Access Compliance Report Public Rights-of-Way (Curb Ramps)

Main Street: PURDY_ST Cross Street: BIRD_RD Location: NE

ADA ID: RPRK211005115041 Ramp Type: Type 1 - Perpendicular Diagonal Initial Pass/Fail: Fail Overall Compliance: No Severity Score: 15

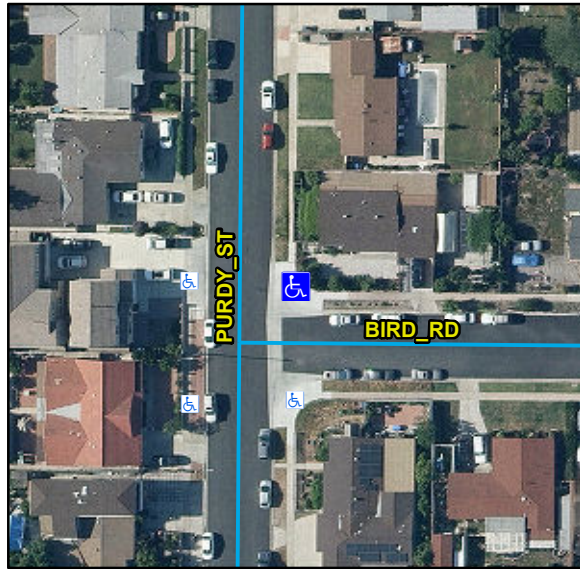
Surveyor Notes:

N/A

Remove & Replace Curb Ramp With Two New Directional Ramps or Equivalent.

R304.2.2, STD 1115
